UNITED STATES PATENT AND TRADEMARK OFFICE

APPLICATION NO.	FILING DATE	FIRST NAMED INVENTOR	ATTORNEY DOCKET NO.	CONFIRMATION NO.
10/801,754	03/15/2004	Gerard Decourieux	03-7341	3440

Office Action Summary	Application No. 10/801,754	Applicant(s) DECOURIOUX ET AL.	
	Examiner Michael Koczo, Jr.	Art Unit 3746

DETAILED ACTION

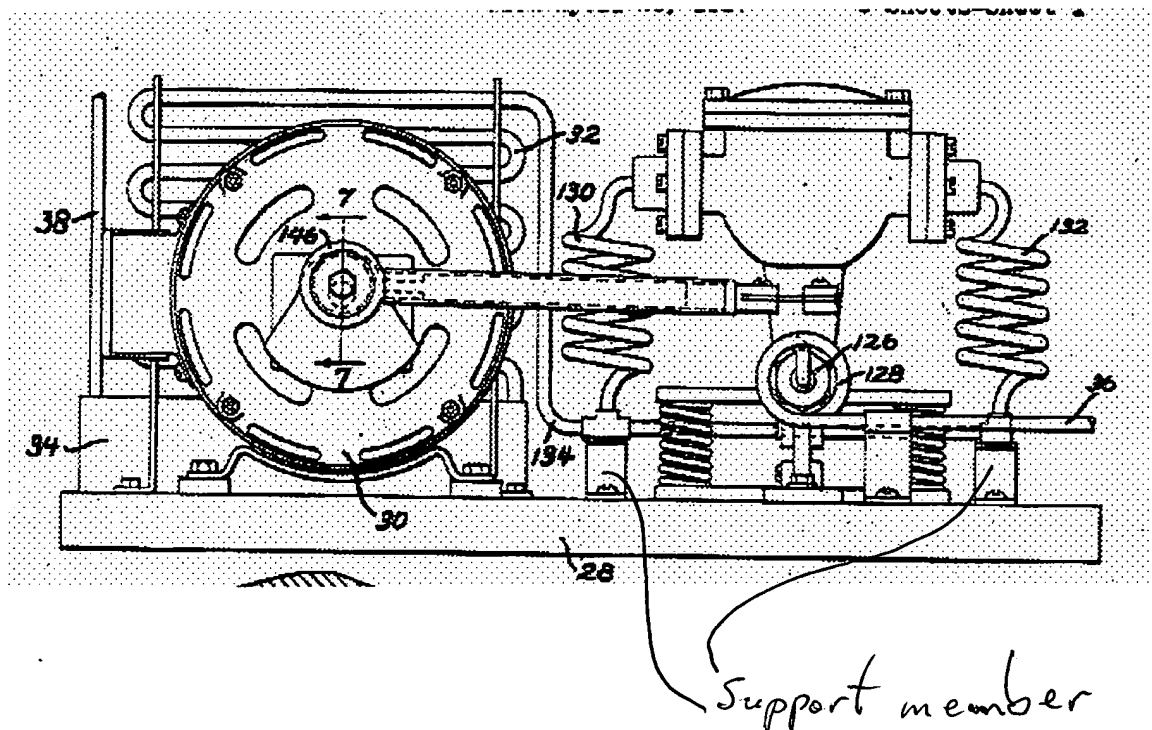
Claims 1, 2, 5 and 8 are rejected under 35 U.S.C. 102(b) as being anticipated by Smith (US 2,234,742). Smith discloses a compressor and pipes 130, 132 connected at their ends to the compressor. The pipes are supported by unidentified support members, which support members are fastened to base 28. See figure 1 reproduced below.

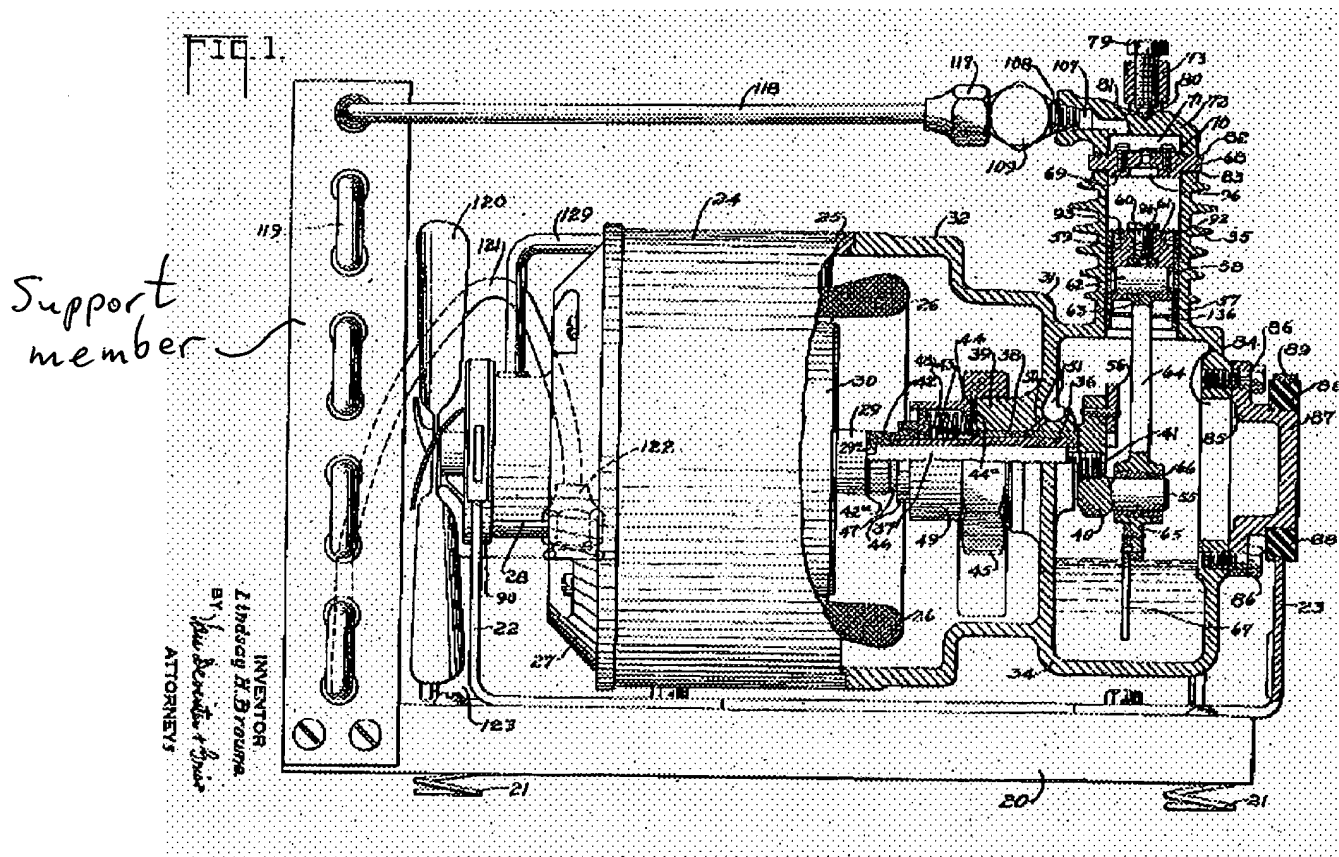
Claims 1, 2, 5 and 8 are rejected under 35 U.S.C. 102(b) as being anticipated by Browne (US 2,136,097). Browne discloses a compressor and pipe 118 connected at its ends to the compressor. Unidentified support members support an intermediate portion of pipe 118 relative to the compressor. The support members are connected to base 20. See figure 1 reproduced below.
